TOWN OF HERNDON, VIRGINIA
ARCHITECTURAL REVIEW BOARD
WORK SESSION AGENDA
AUGUST 7, 2019
HERNDON MUNICIPAL CENTER
2nd floor, LARGE CONFERENCE ROOM
777 LYNN STREET
7:30 P.M.

STAFF REPORT
Architectural Review Board
August 2, 2019

Case Number & Type: ARB #19-29; Wall Signs
Case Summary: Install new business signs on an exterior wall of an existing single tenant commercial building
Case Location: 1040 Elden Street, Dulles Park Shopping Center

CHANNEL LETTERS SIGNAGE ON THE CUSTOM FABRICATED BASE BOARD (Store Front)

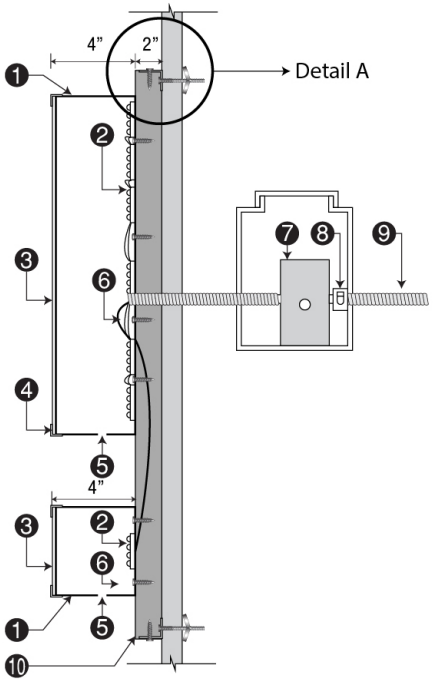
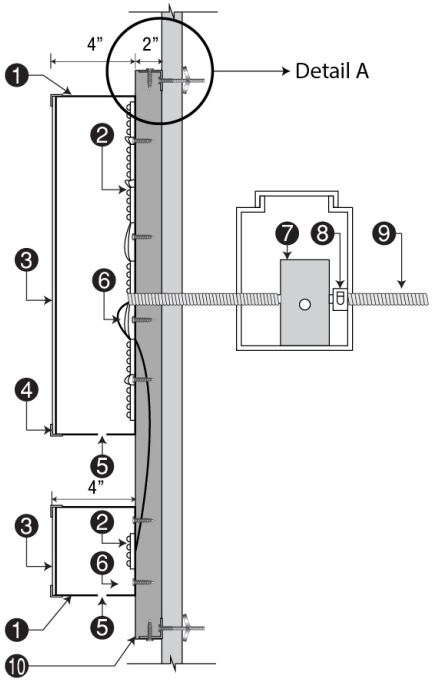
2. The proposed signs meet the Town Zoning Ordinance, Section, 78-140.6. - General standards for all signs regarding, the sign types, design, placement, and illumination. However, staff has noted that the scale and dimensions of the submitted drawings appear slightly inaccurate, as noted above.

Recommended Motion:	Motion for approval of ARB #19-29, in accordance with Alternative #3, with the following condition: 1. The applicant shall revise the drawings to a common architectural/engineering scale with accurate and complete dimensions for staff zoning compliance review prior to issuance of a building permit; and 2. The proposed sign shall be constructed /installed in substantial conformance with the application and supporting materials as submitted June 18, 2019 and subsequent updates required to meet Condition #1.

Proposed Sign

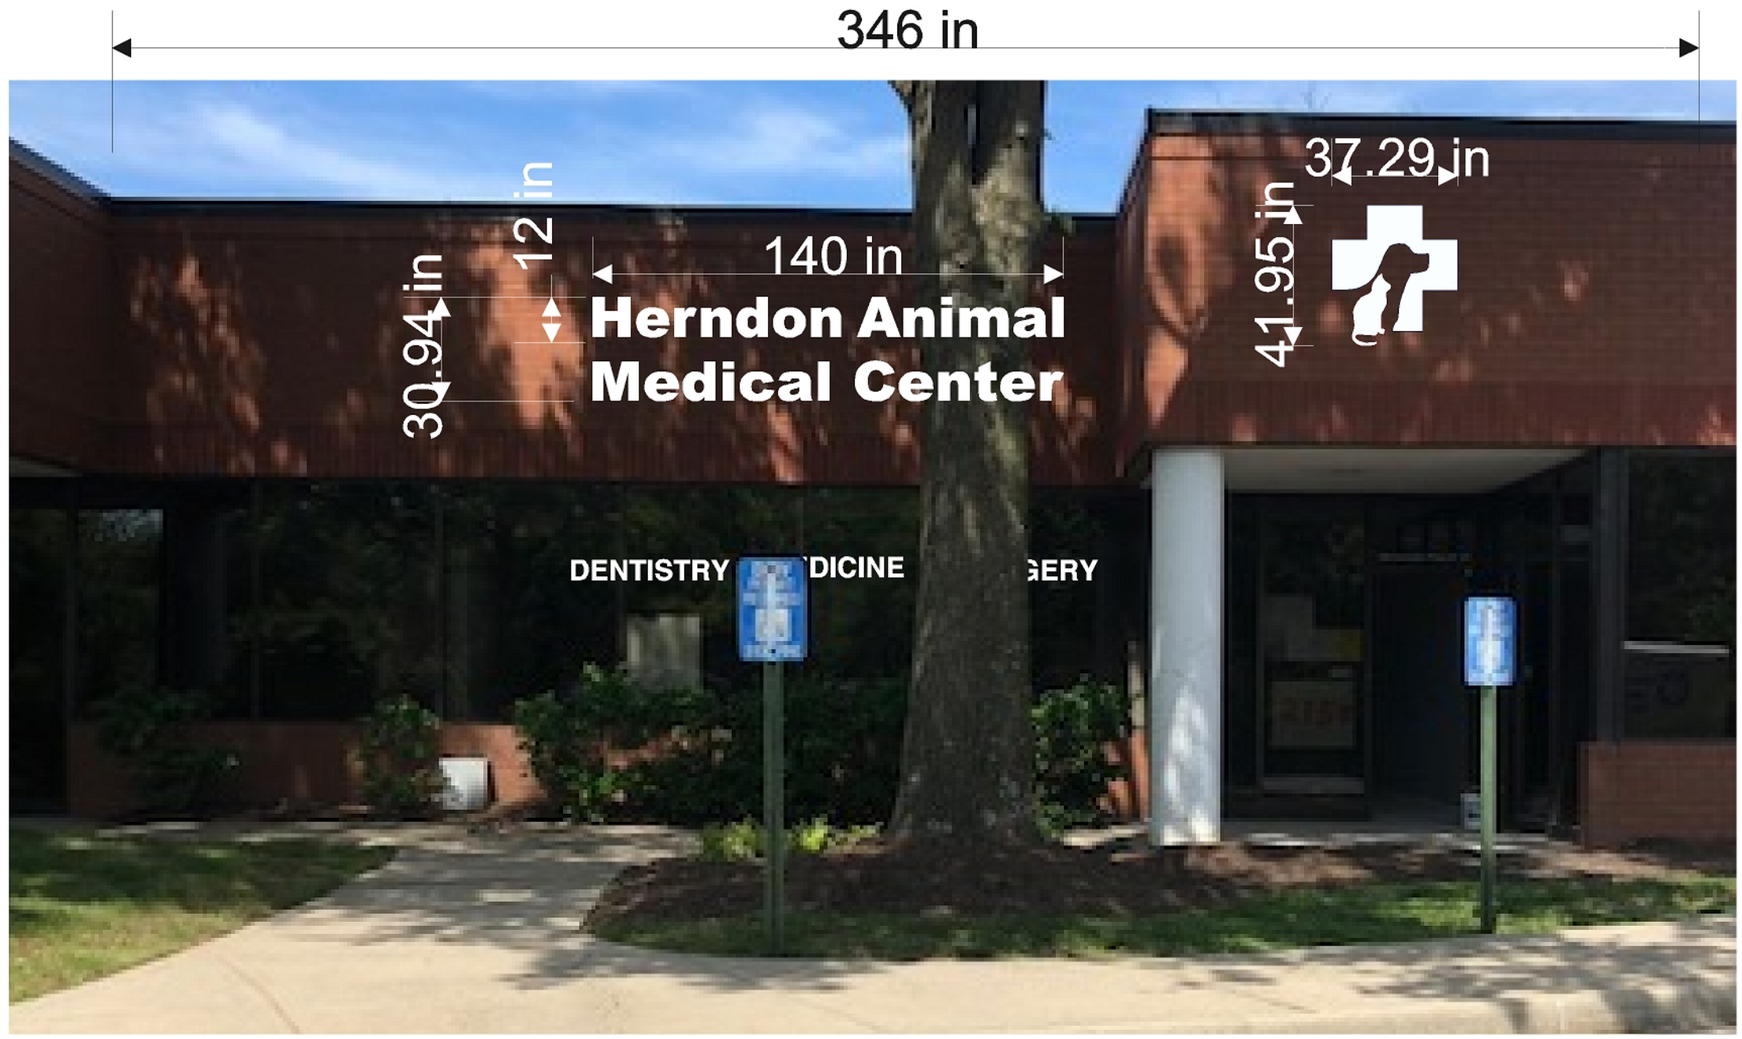
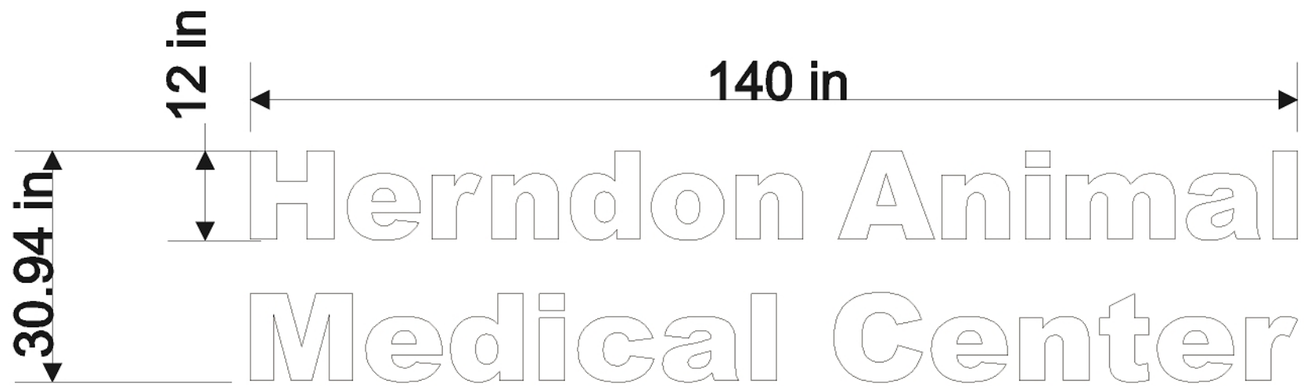
1. The application proposes a total of 40.9 square feet of signage to be distributed on two signs on the east facing elevation to identify the tenant business. Section 78-141.4. - Sign standards for commercial districts, Table 141.4(a) specifies that in the O&LI, Office & Light Industrial zoning district one (1) square foot of sign area for each linear foot of frontage is authorized with a maximum of 150 square feet per sign. In this case, the tenant space occupies 28.8 linear feet of frontage along the east façade along Herndon Parkway, and thus the maximum sign area for this tenant space is 28 square

feet. The proposed signage does not meet the sign area requirements of the referenced zoning ordinance section. In addition, staff has noted that the scale and dimensions of the submitted drawings appear slightly inaccurate, though staff has made conservative calculations using the applicant's conceptual dimensioning. As such, staff will require revised and accurate drawings to confirm staff's calculations to ensure compliance with the Town's Zoning Ordinance.

Zoning compliance is required for the proposed sign design prior to the Board considering and acting upon any case. If the applicant can reduce the overall sign area to comply with Section 78-141.4. - Sign standards for commercial districts, Table 141.4(a) with updated submission materials submitted no later than August 14, 2019, staff can review the updates and provide a revised recommendation for the Board's consideration. Presuming zoning compliance is achieved in the revised submission materials, the Board could act on the case at the August 21, 2019 ARB Public Hearing.

4 **WEST ELEVATION - NEW**

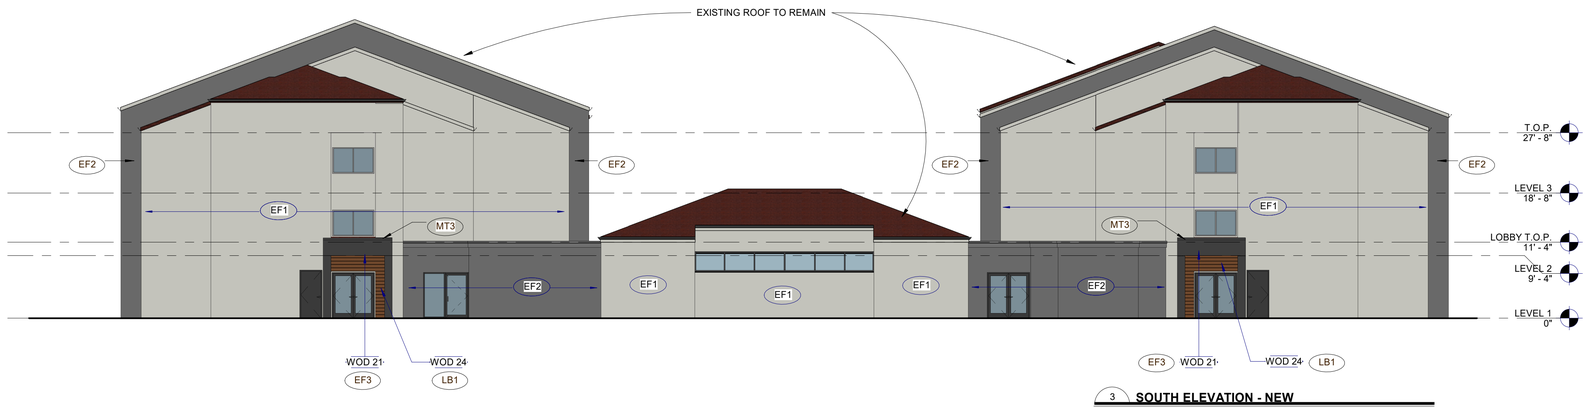
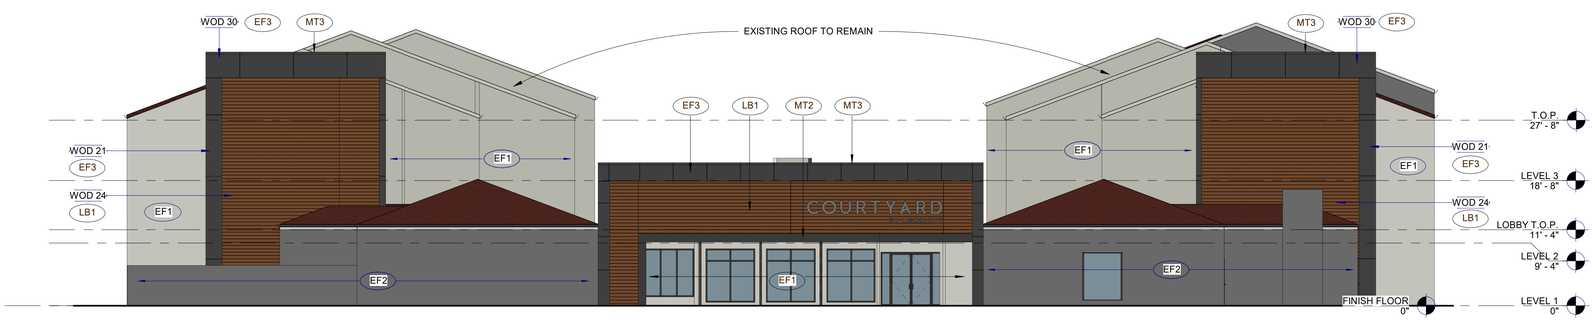
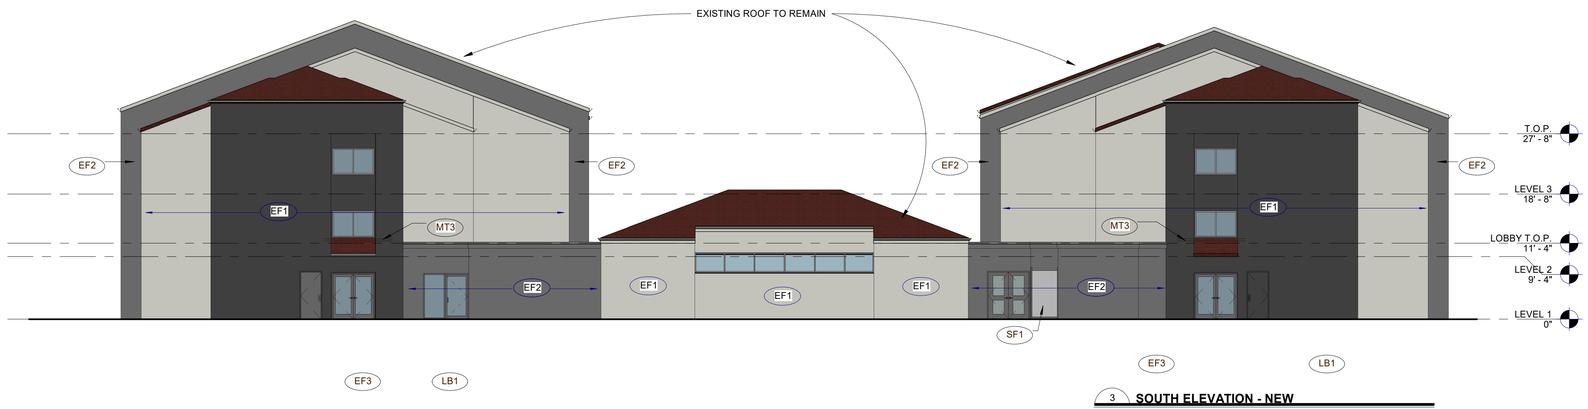
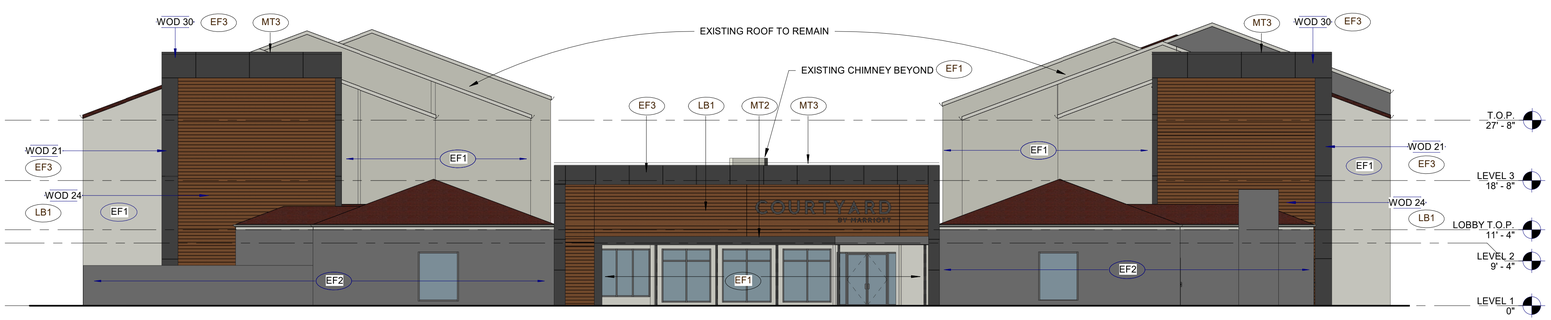
The applicant is proposing to amend the design from the previous ARB approval (ARB #19-09) by reducing the use of the Longboard® metal panel system to be installed in a horizontal orientation with a faux wood finish on exterior walls around stairwells enclosures to three stories and around selected exterior entry/exit doors on three exterior primary elevations (East, West, and South). In addition, the application proposes to introduce the new areas of EIFS colored in Benjamin Moore ® Graphite (very dark gray or charcoal color) flat acrylic paint in locations where the metal panel system is proposed for reductions and on the EIFS covering two mechanical shafts on the east and west elevations (Attachments #1, #2, and #3).
